**CITY COUNCIL  
CHRIS HOLDEN  
COUNCILMEMBER  
DISTRICT 3**

**TO: Jane Rodriguez, City Clerk**  
**FROM: Chris Holden, Councilmember, District 3**  
**RE: Call Up – Raymond Theatre**

Re: **NOTICE OF DECISION  
APPLICATION FOR CONCEPT DESIGN  
121-129 North Raymond Avenue**

**TO:** Design Commission  
**FROM:** Richard J. Bruckner, Director, Planning & Development Department  
**SUBJECT:** **Application for Concept Design Approval** PLN 2004-00002  
121-129 North Raymond Avenue (Council District 3)  
**DATE:** Revised for meeting on April 12, 2004

Figure 2  
 Cross-Section of Proposed Reuse  
 of the Raymond Theater

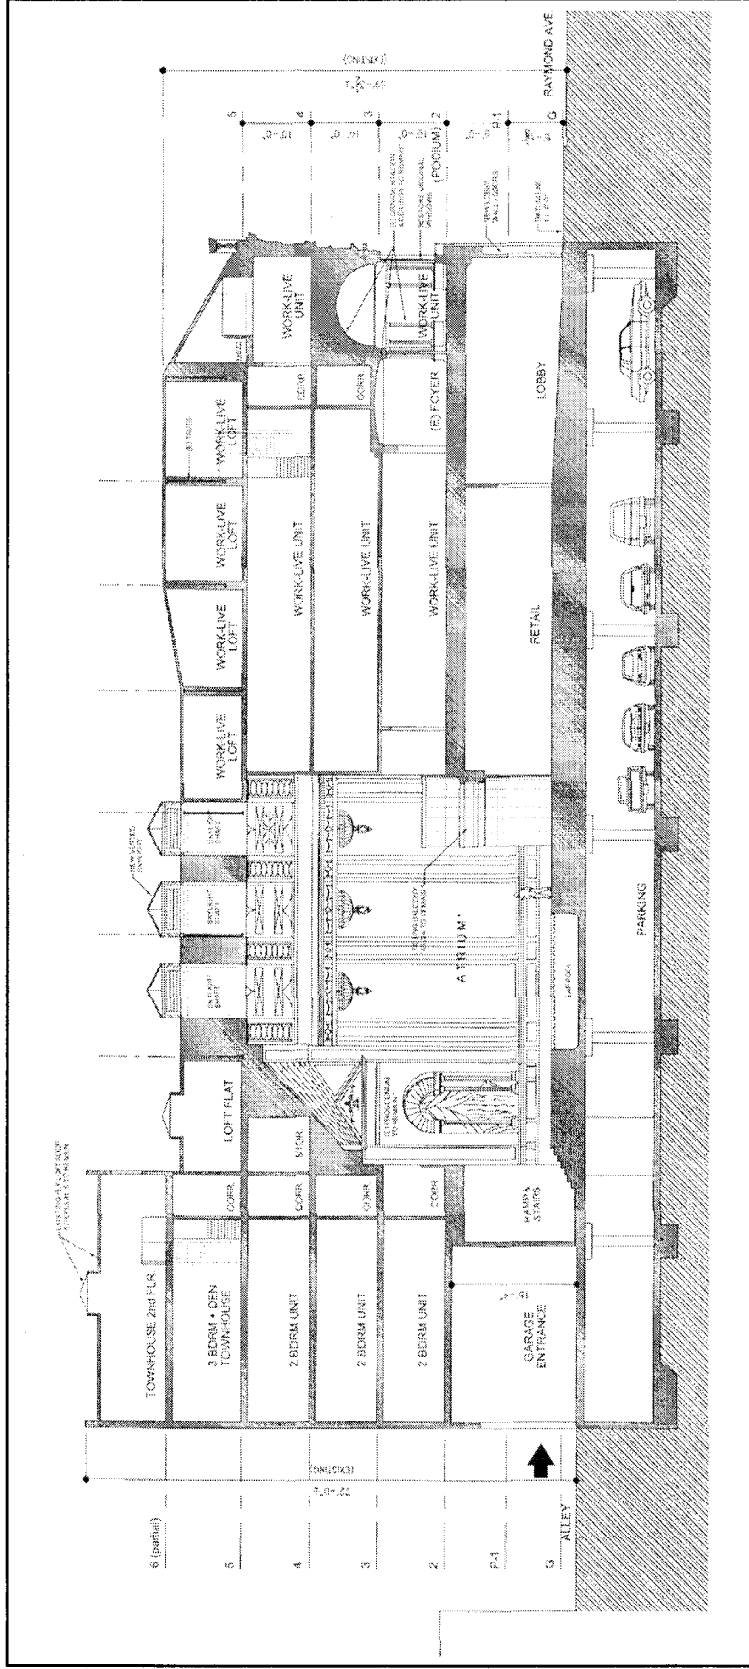
**Theater Building:** The modified project proposes changes to the design of the original project to convert the stage/fly loft area and balcony to 21 apartment units (loft flat, townhouse, work/live, and work/live plus loft); remove the character-defining ramps in the lobby to accommodate a single, 6,190-square-foot commercial space, as well as the residential lobby and building entrance foyer; and construct an atrium, leveled to the same height as the lobby floor and open from floor to ceiling, with a decorative lap pool and changing rooms in the main portion of the auditorium. Figure 2 shows the cross-section of the Raymond Theater building.

Figure 3  
Raymond Theater Atrium Ceiling Detail

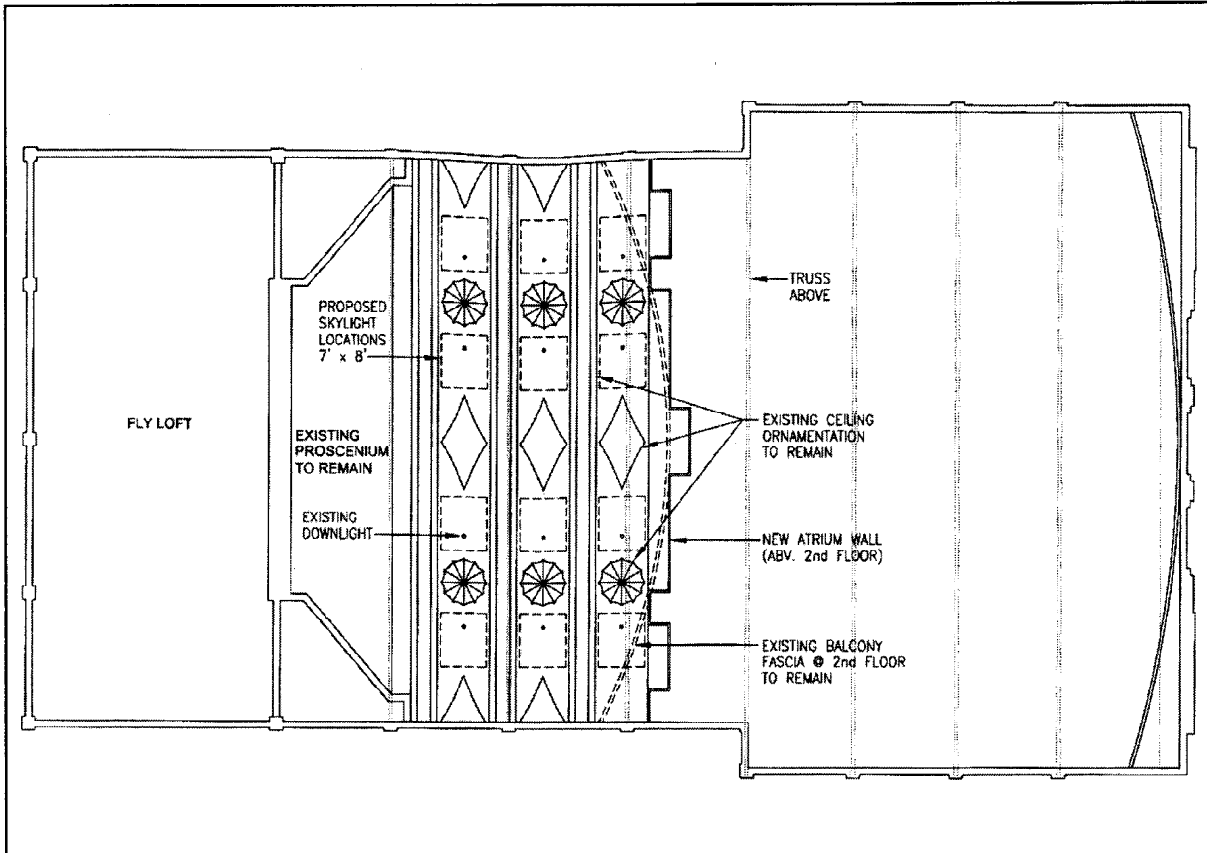
Twelve new skylights are proposed for installation in the roof of the existing auditorium of the Raymond Theater (see sheets 7, 8, & 9 in plans and elevations, ATTACHMENT E). These skylights are required by building code to provide light and air for occupancy of the interior spaces that open into the atrium (see longitudinal section on sheet 12, ATTACHMENT E). The building official has determined that this condition satisfies §1202 and §1203 of the building code subject to calculations required for operable area. The number of these skylights and their size, height, profile, and finishes will be presented to the Commission for further review during 50% review and final review.

This development approach will require the cutting of holes into the auditorium ceiling, as shown in Figure 3, for the skylights. This is a new project feature not included in the original project.

These modifications would result in additional alterations to the interior, in particular alterations to the ceiling of the auditorium space to accommodate the skylights, thereby reducing the design integrity of the auditorium further than was originally anticipated. Other minor proposed design changes to the project description include the addition of a pool within the atrium area and the relocation of the demising wall between the atrium and retail spaces and the residential units occupying the area above and below the theater balcony.

- q) The proposed new **skylights** shall be eliminated from the roof of the theater auditorium.
- r) The Commission shall conduct **final design review**;
